TVGA CONSULTANTS
☐ NO EXCEPTIONS TAKEN ☐ REJECTED
☒ FURNISH AS CORRECTED
☐ REVISE AND RESUBMIT
ENGINEER has reviewed Shop Drawings and Samples and other data which Contractor is required to submit, only for conformance with the information given in the Contract Documents and compatibility with the design concept of the completed Project as a functioning whole as indicated in the Contract Documents. Such reviews do not extend to means, methods, techniques, sequences or procedures of construction or to safety precautions and programs incident thereto. Such reviews do not extend to any LEED certification or accreditation. Contractor is responsible for dimensions to be confirmed and correlated at the job site; for information that pertains solely to the fabrication processes or to techniques of construction; and for coordination of the work of all trades.
BY JM
DATE 17-05-09

DESCRIPTION: GIRDER - 219G3E

STRUCTURE:	RAMP D VT RTE 279 OVER WALLOOMSAC RIVER BRIDGE NO. B15N BENNINGTON COUNTY	DRAWN: WR	DATE: 07/13
		CHKD: DO	DATE: 08/17
LOCATION:	BENNINGTON, VERMONT	JOB NO.	DWG NO.
PROJ NO.	AC NH 019-1(51)	408-2	219
CUSTOMER:	KUBRICKY CONSTRUCTION		REV. △

ONE - GIRDER - 219G3E (DEV.)

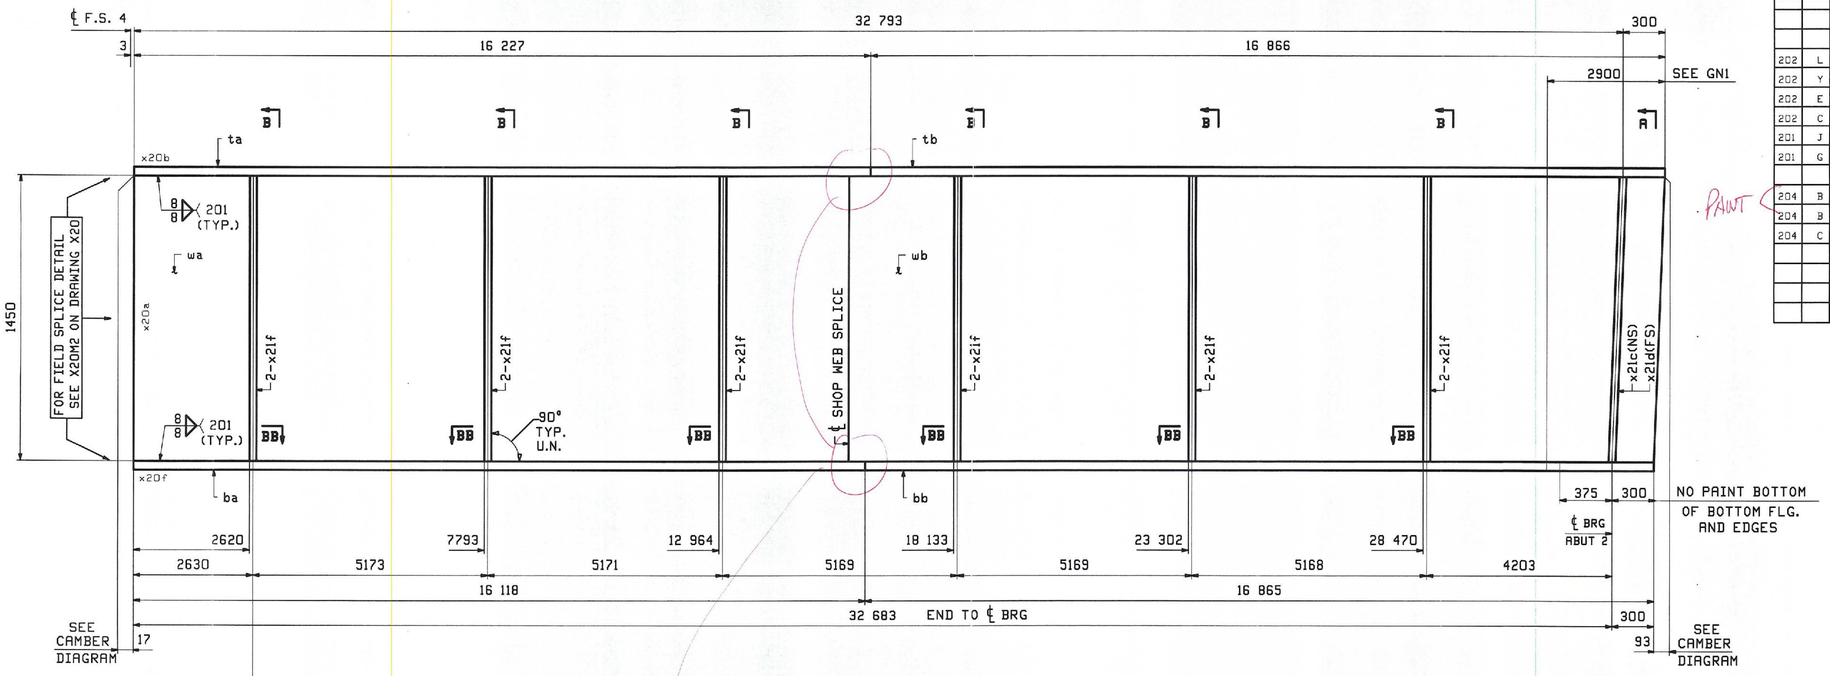
Per Drawing BR 287 "Girder Elevation (Ramp D)" and VTRans Structures Design Manual Section 20.6; "Shop flange butt welds and Shop web butt welds shall preferably have a 600 mm offset".
